UNITED STATES PATENT AND TRADEMARK OFFICE

APPLICATION NO.	FILING DATE	FIRST NAMED INVENTOR	ATTORNEY DOCKET NO.	CONFIRMATION NO.
10/821,358	04/09/2004	Sheng-Shiou Yeh		1201
25859	7590	07/19/2005		
WEI TE CHUNG FOXCONN INTERNATIONAL, INC. 1650 MEMOREX DRIVE SANTA CLARA, CA 95050			EXAMINER CHEN, LUCY P	
			ART UNIT 2871	PAPER NUMBER

Office Action Summary	Application No.	Applicant(s)	
	10/821,358	YEH ET AL.	
	Examiner	Art Unit	
	Lucy P. Chien	2871

DETAILED ACTION

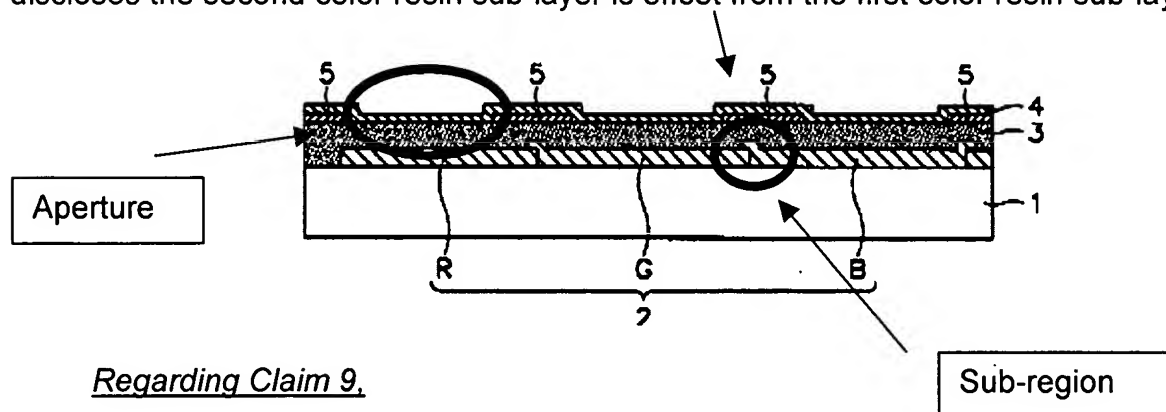
Kim et al discloses (Figure 5) the first color resin sub-layer (a small part of B on top of G) on the transparent substrate (1) formed on the second color resin-sub-layer (G under a small part of B) on the first color resin sub-layer.

In addition to the admission and Kim et al disclosed above, Kim et al also discloses the second color resin sub-layer is offset from the first color resin sub-layer.

In addition to the admission and Kim et al disclosed above, Kim et al also discloses forming contiguous RGB color resin regions on the transparent substrate (1) and forming RGB color resin sub-regions in voids between adjacent RGB color resin regions. (as shown in figure above).

In addition to the admission and Kim et al disclosed above, Kim et al also discloses the RGB color resin regions corresponding to respective apertures (Figure above (5)).

In addition to the admission and Kim et al disclosed above, Kim et al also discloses the RGB color resin sub-regions correspond to respective portions of the black matrix between apertures. (shown in figure above)
